PRIMARY HEALTH CARE CENTERS
NUMBERED KE-01, KE-02,
KE-03, KE-04, AND KE-05
KIRKUK, IRAQ

SIGIR PA-06-042
SIGIR PA-06-043
SIGIR PA-06-044
SIGIR PA-06-045
SIGIR PA-06-046

SUBJECT: Report on Project Assessments of Primary Health Care Centers Numbered
KE-01, KE-02, KE-03, KE-04, and KE-05 in Kirkuk, Iraq (Report Numbers
SIGIR-PA-06-042, PA-06-043, PA-06-044, PA-06-045, and PA-06-046)

Primary Health Care Centers Numbered KE-01, KE-02, KE-03, KE-04, and KE-05 Kirkuk, Iraq

Site Photo 77. First floor structural beams and column

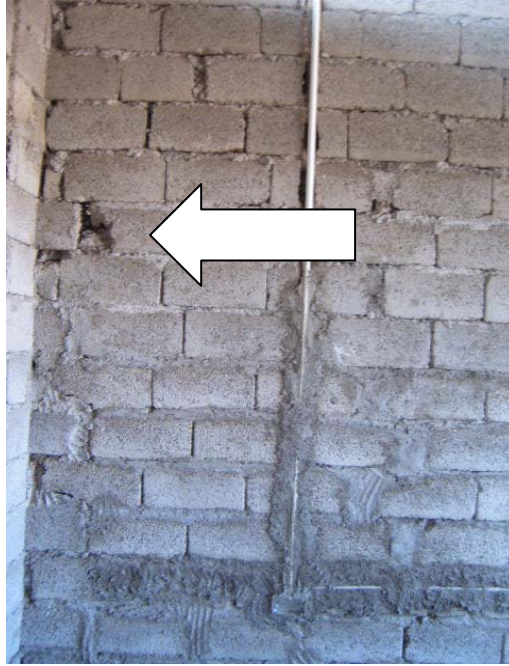
At the time of the site assessment, all reinforced concrete columns, slabs, and ceiling beams appeared complete and most of the formwork removed. For a picture of the concrete columns and remaining formwork, see Site Photos 77 and 78, respectively. The contract and design specifications required cast in-place reinforced concrete structural beams, columns, and slabs. We assessed only a fraction of the structural concrete work due to time constraints on site. The ground floor columns, ground floor structural beams, ground floor ceiling slab, interior stairwell, x-ray room walls, first floor structural beams, first floor columns, and first floor ceiling slab all appeared almost complete; however, we identified quality issues. During the site assessment, we observed work in progress on the block walls. The block walls appeared to be of substandard construction with quality problems. For instance, we observed block rows not level, walls with unfilled gaps between blocks, broken blocks, blocks improperly installed, and bricks of different sizes used in the wall construction. Site Photo 79 shows broken blocks in wall construction. We observed preparatory work in progress on the roof; however, at the time of the assessment, we did not observe roof construction activities underway (Site Photo 80).
